ORIGINATION FORM

Proposed Revisions to a Standard Plans Index
(Please provide all information — Incomplete forms will be returned)

Index Number: 102-665
Sheet Number (s): 1
Index Title: Limited Access, Temporary Opening

Sheet 1: Revised Details and Notes 1-3, 9 & 12; Updated Symbols; Deleted Notes 4 & 6; Moved Notes 5, 7, 8, & 13 to Spec 102.

INDEX	SHEET
102-665	1 of 1

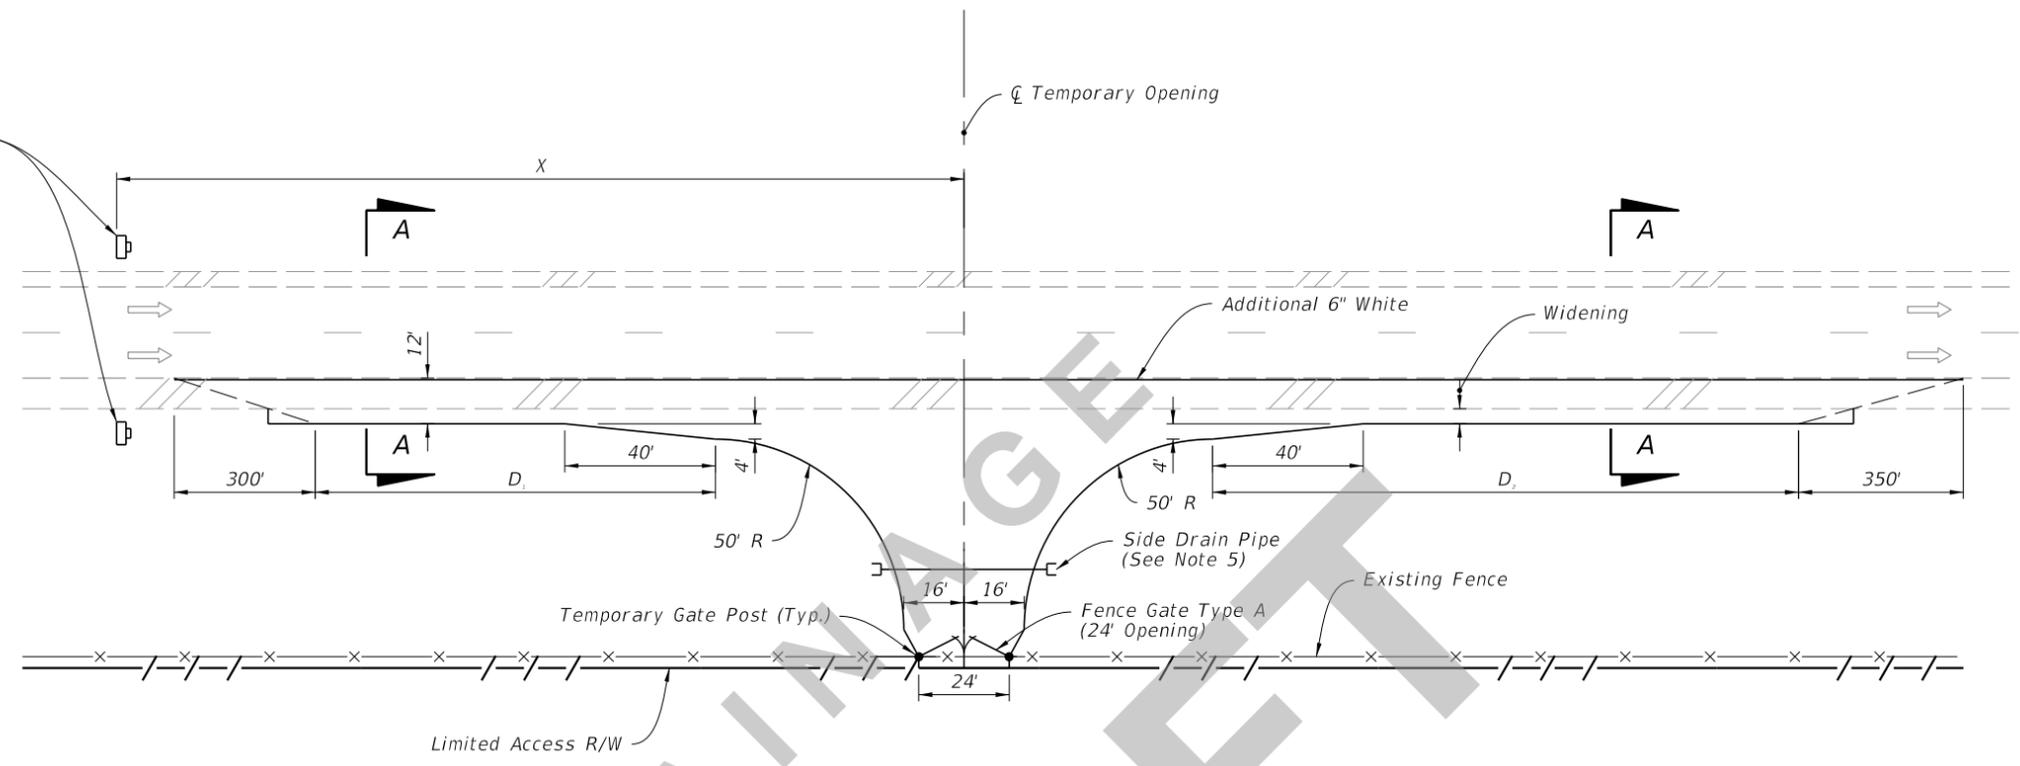
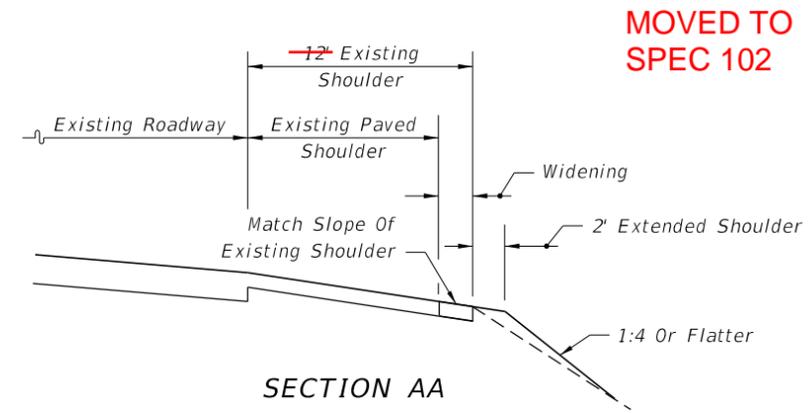
REVISED DETAIL

REVISED NOTES

4. ~~Access openings shall not be constructed directly opposite temporary median crossovers nor within 2000 ft. of temporary median crossovers.~~
5. Access openings shall be within the project limits and shall not be used for transporting materials to or from any other project. The acceleration-deceleration surfaces shall be paved. RAP material is acceptable for driveway surfacing.
6. ~~Any Motorist Aid Call Boxes affected by the temporary access openings shall be relocated outside the limits of access lanes and remain in use during construction. Upon removal of access lanes, call boxes shall be returned to their previous location. Temporary relocation and restoration of call boxes shall be at the contractor's expense.~~

9. The contractor shall not vary from the plan detail without approval of the Engineer.
10. Gates shall be removed and access opening locations shall be restored to preconstruction condition immediately upon completion of activities utilizing the materials being transported through the openings whether or not the project is completed.
11. Failure to comply with any provision of the access opening plan shall be cause for terminating use of all openings. Upon notification by the Engineer, the contractor shall cease hauling and begin restoration of affected areas. Under this condition expense of removal, restoration and of additional hauling distances shall be borne by the contractor.
12. No guardrail or barrier wall will be removed for access openings.

UPDATED SYMBOLS

- NOTES:**
1. X = Work Zone Sign Distance, see Index 102-600 for "X" value.
 2. Access openings across limited access right of way and use of this Index are prohibited unless specifically permitted in the Contract Documents. When permitted in the Contract Documents and prior to construction of any opening, the Contractor must submit, in writing, a request identifying specific locations within the project limits for approval by the Engineer.

3. Locate temporary openings in areas having adequate sight distance.
 4. Do not locate temporary openings within 1.5 miles of interchanges, nor within 2000 feet of the acceleration-deceleration lanes at rest areas, median openings, other access openings, or other highway service areas.

5. Do not remove existing guardrail or barrier for temporary openings.
 6. Use mitered end sections for any end sections within the clear zone.
 7. Match cross slope of existing shoulder for widening.

8. Provide 2' of unpaved shoulder outside of the widening.
 9. No more than two (2) access openings will be allowed on each project.
 10. Do not vary from the plan detail without approval of the Engineer.
